ASSESSMENT REPORT

Block 11 - Central Park, Chippendale (Former Carlton United and Brewery Site) SSD 6376 MOD 1

Figure 3: Wind measurement locations at O'Connor Street Park and the retail units (Base image source: Modification application)

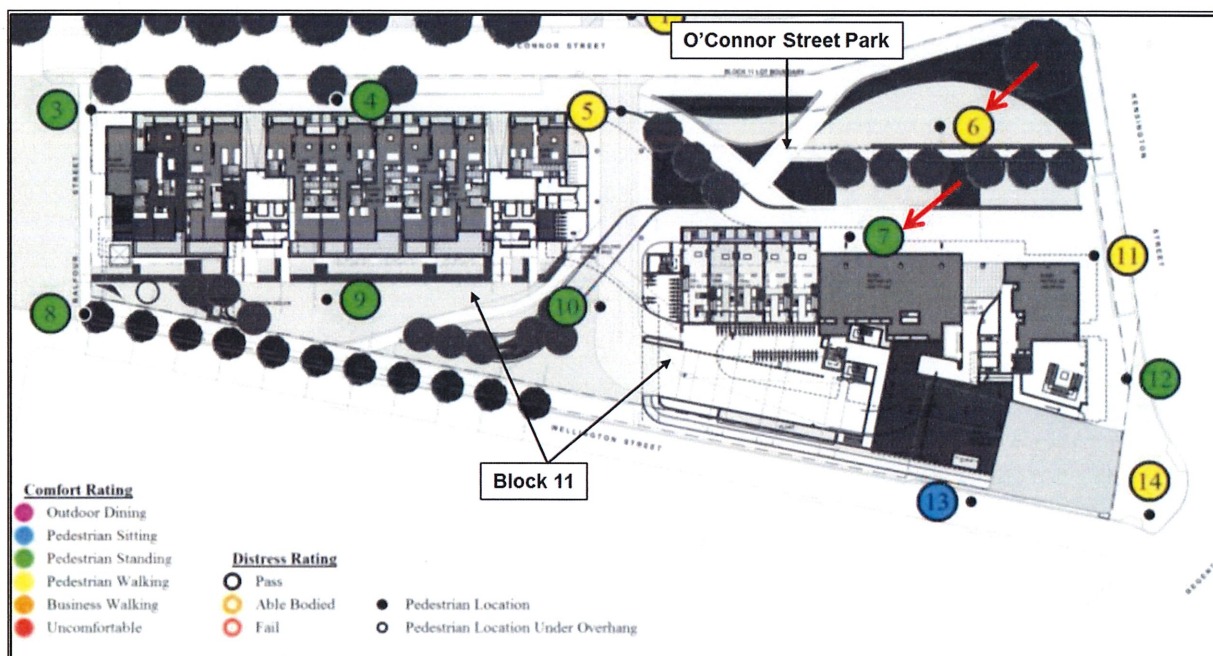
- it is not able to meet the wind requirements of condition B7 ('pedestrian sitting' comfort level) given the site constraints;
- the planting of a significant number of trees within the park would have a negligible impact on wind reduction and would form a visual barrier;
- planting would reduce solar access and security within the park; and
- wind impacts within the park are similar to other nearby inner city parks.

As proposed, the planting within O'Connor Street Park, achieves a wind environment providing a 'pedestrian walking' comfort level, similar to a number of other inner city parks, such as Tumbalong Park. The Department notes the Wind Report states that to meet a 'pedestrian sitting' comfort level within the park as required by the condition, mature trees would need to essentially cover the full extent of O'Connor Street Park. This would result in other adverse amenity impacts, such as loss of solar access, which would also reduce the utility of the park for passive recreation.

- the significant tree planting required to reduce wind impacts would reduce usable open space, solar access and safety and security within the park. Therefore, compliance with the condition would potentially result in a net loss of amenity;
- despite not having a suitable wind environment for pedestrian sitting, the park would still provide a pleasant place to sit on non-windy days, a suitable space for passive recreation, a pleasant pedestrian connection and landscaping which complements other nearby open space including the adjacent Chippendale Green;
- the wind environment is similar to many other open spaces within inner city locations where the urban form comprises high density development; and
- residents have access to other nearby open space, such as Chippendale Green, which achieve comfort ratings suitable for 'pedestrian sitting'.

The Department also notes that the original concept plan for Block 11 did not include a consolidated park at this location. While the proposal does not achieve the desired wind environment, the park would still provide additional green space within this inner city location for the benefit of the community. On this basis, the Department is satisfied the proposal is acceptable.

Figure 4: Location of vertical screens to retail units (Source: Modification application)

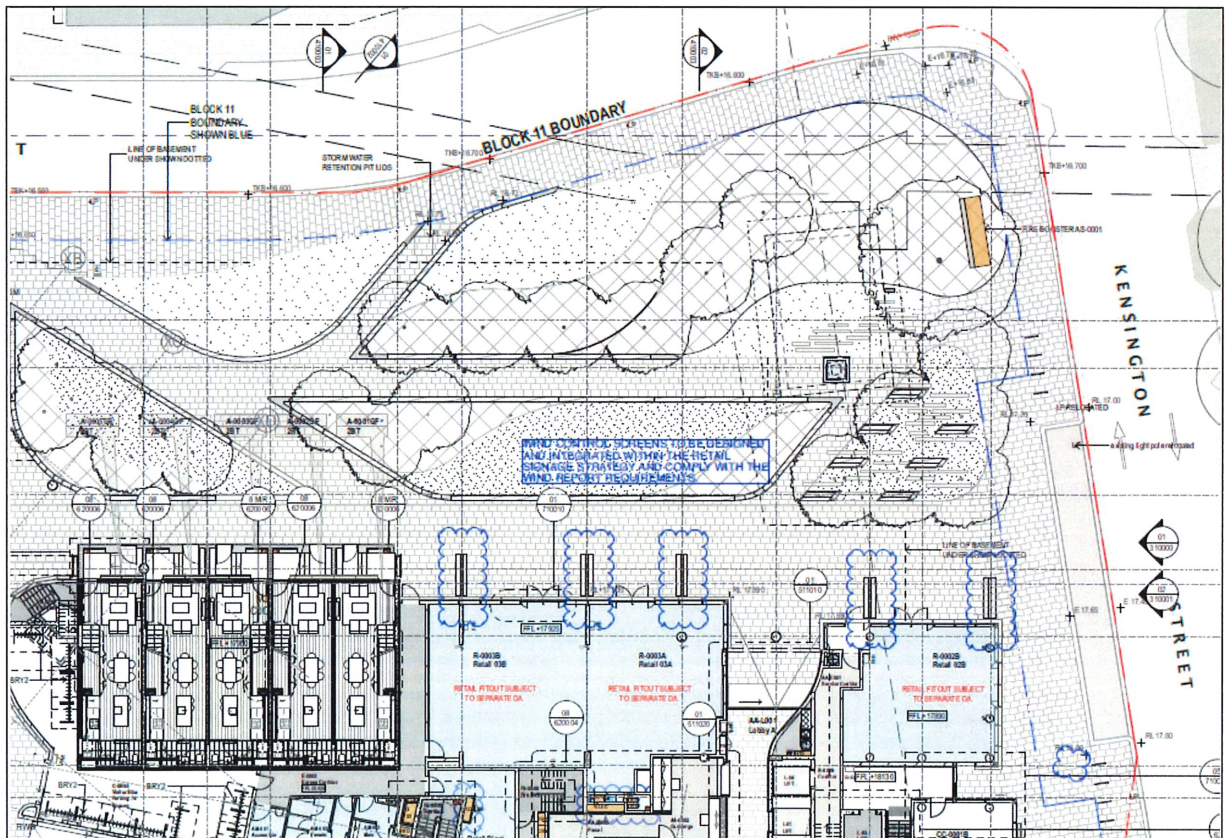
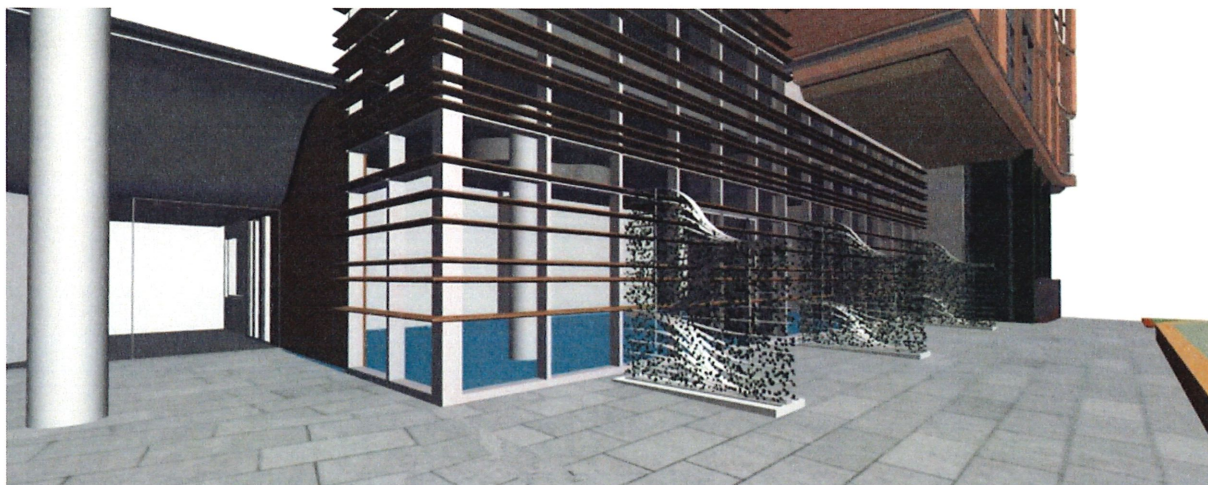
To address wind impacts outside the retail units the modification includes the installation of vertical screens, with climbing plants, angled perpendicular to the ground floor retail unit frontages (refer to **Figure 4 and 5**). The Applicant has stated that subject to the installation of the screens, the areas between them would meet the 'pedestrians sitting' criterion without the need for additional shielding.

To ensure the proposed vertical screens to the retail units do not have an adverse security impact, the Department considers appropriate sightlines should be retained through the screens. The applicant has confirmed while planting is required to mitigate wind impacts, views could be retained through the screens subject to appropriate species selection. The Department has therefore recommended the inclusion of a condition requiring appropriate views be maintained through the screen.

The Department considers the treatments proposed for the retail units and childcare facility adequately ameliorate wind impacts to these spaces and address the aims of Conditions B8 and B9.
